The Street – Suggested
Road Safety
Improvements

Suggested Improvements

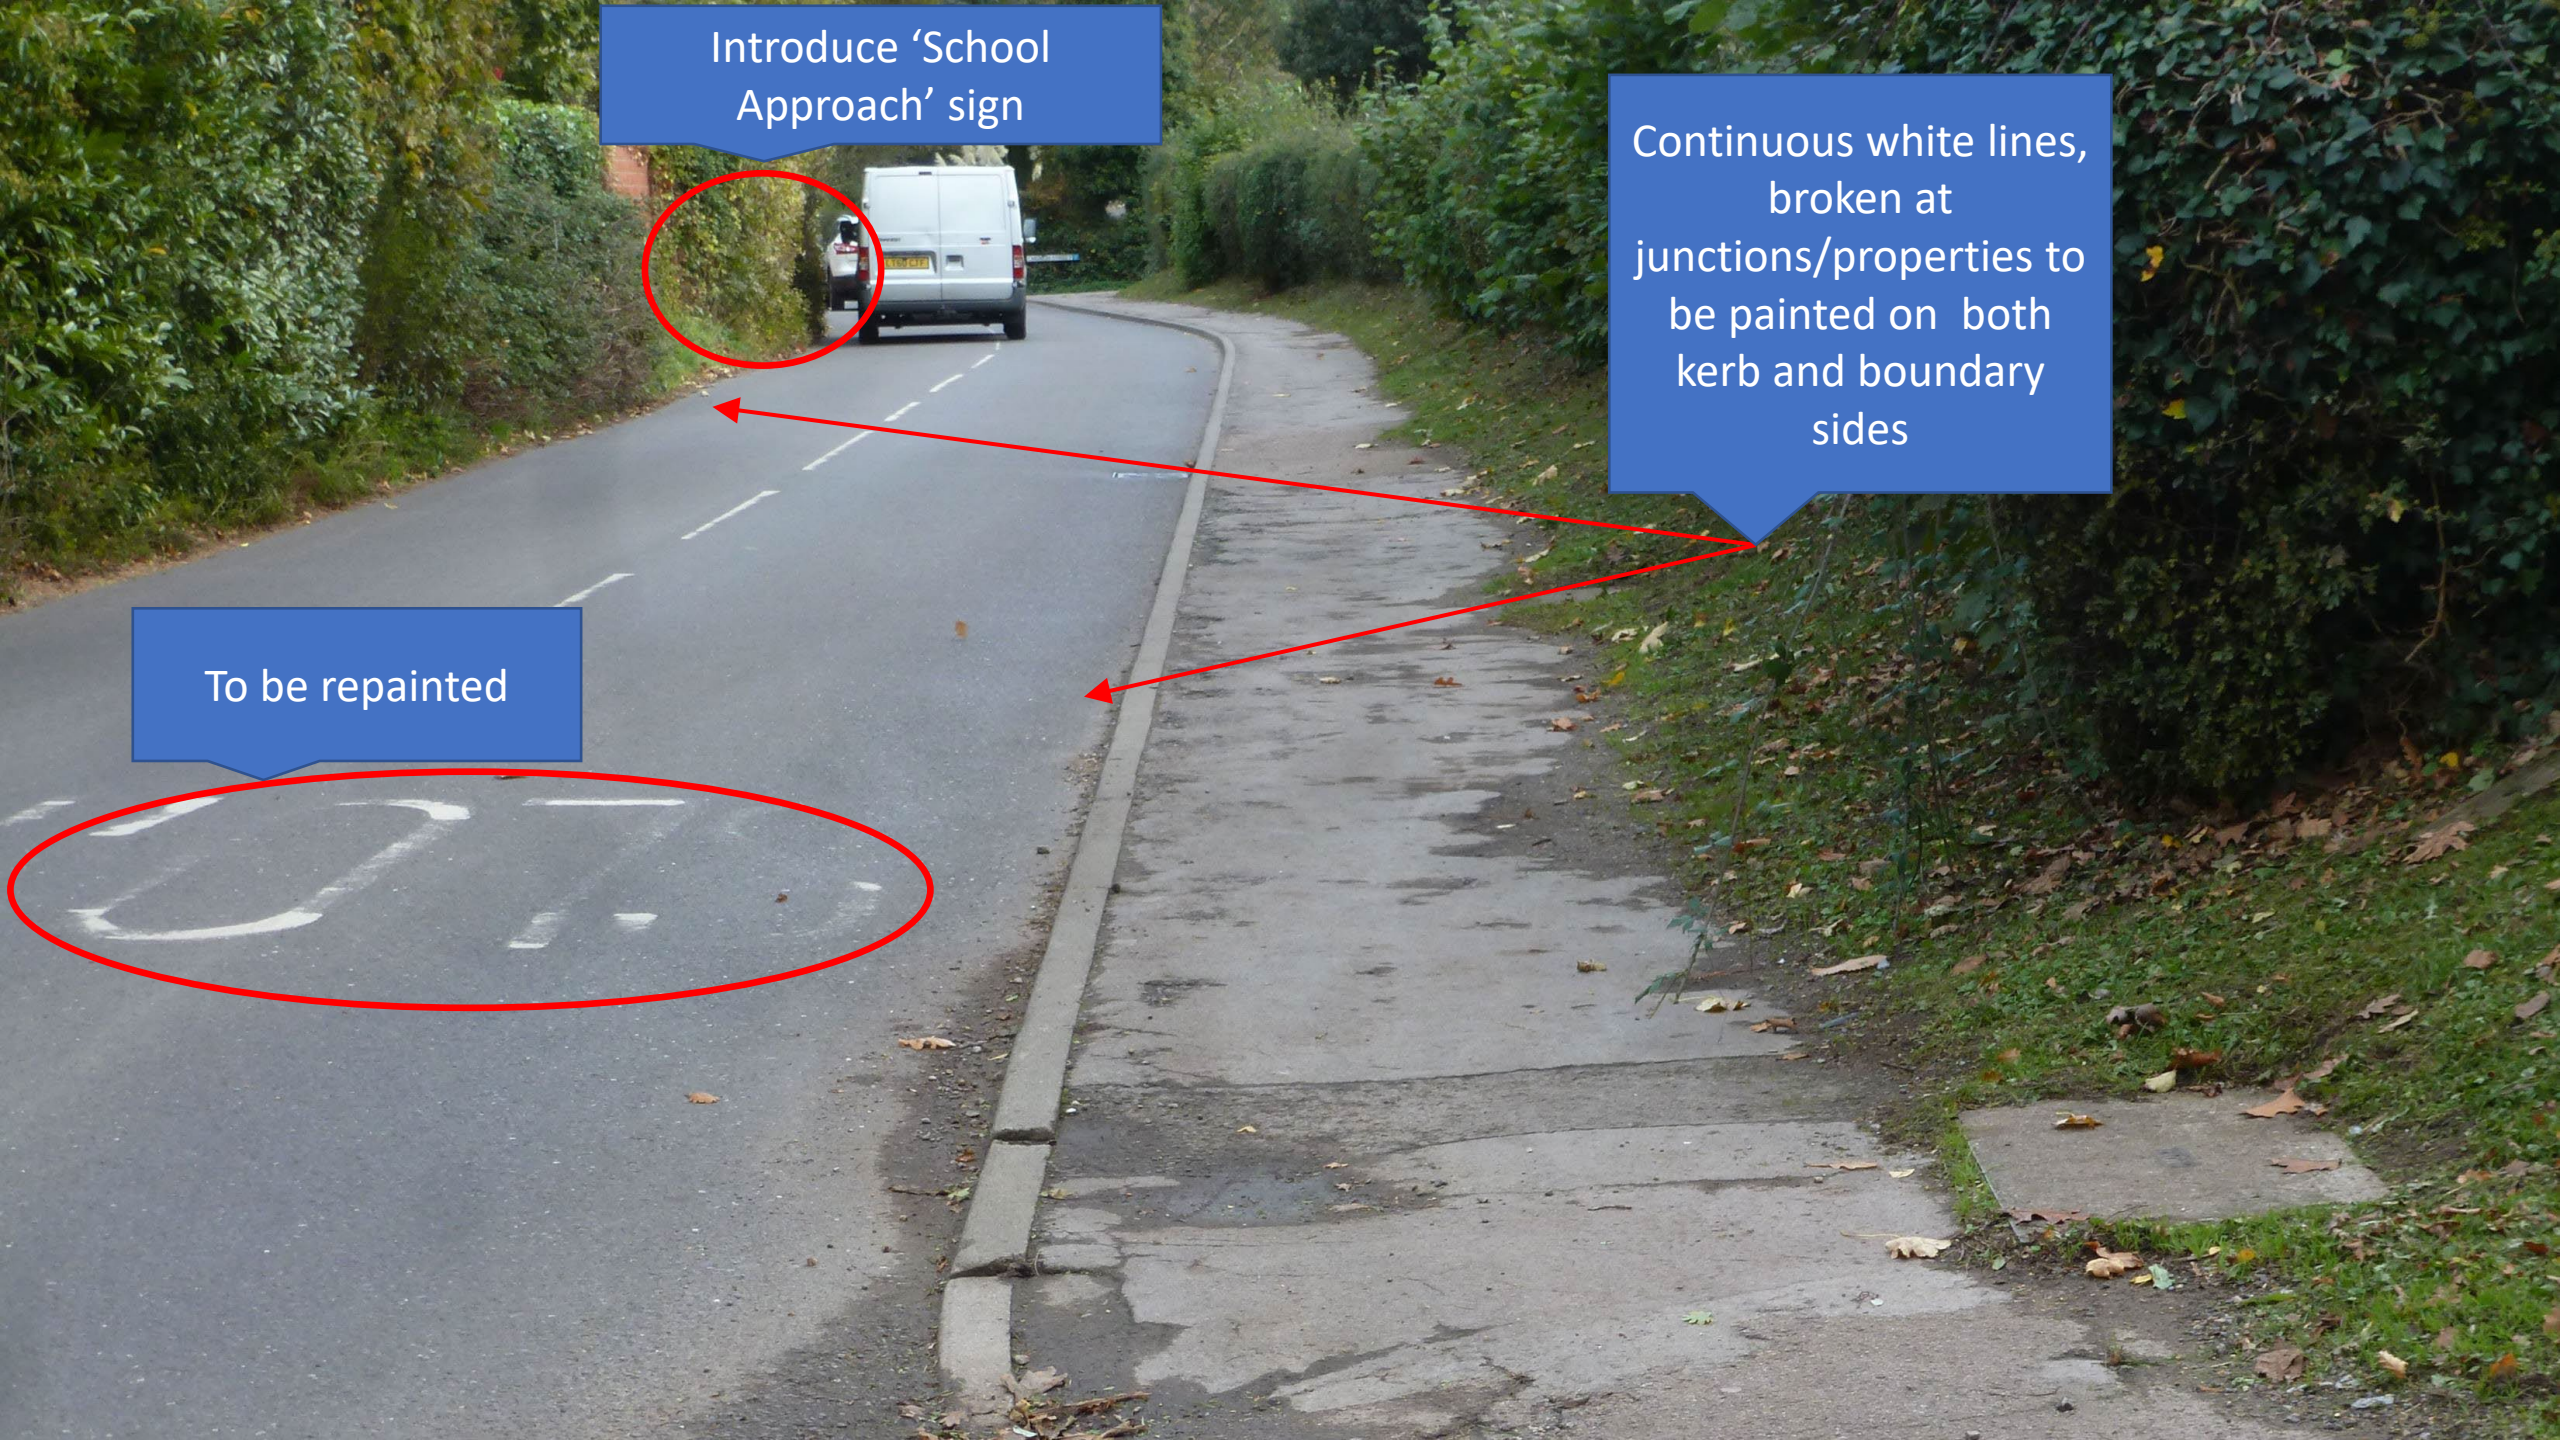
Combination of very low kerb,
narrow road and no centre
markings results in many vehicles
mounting the pavement

Centre lines erased – to be repainted with broken white lines

Continuous white lines, broken at junctions/properties to be painted on kerb side
